Access Compliance Report Public Rights-of-Way (Curb Ramps)

| Intersection ID: 44730 | Main Street: BENFIELD_RD | Cross Street: KOTLIK_DR | Location: E |
| ADA ID: EC1C72969244 | Ramp Type: Directional1 | Initial Pass/Fail: Fail | Overall Compliance: No Severity Score: 37.5 |

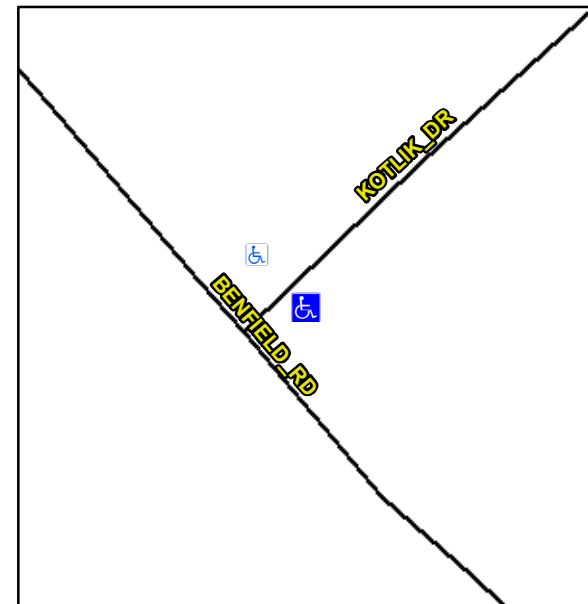
R304.2.2, R304.5.3

| Compliance | Description | Data | Compliance | Description | Data |
|------------|-----------------------|-------|------------|-----------------------------|------|
| No | Ramp Slope (%) | 12.0 | N/A | Grade Break XSlope (%) | 0.0 |
| No | Ramp XSlope (%) | 6.6 | | | |

Remove & Replace Entire Ramp.
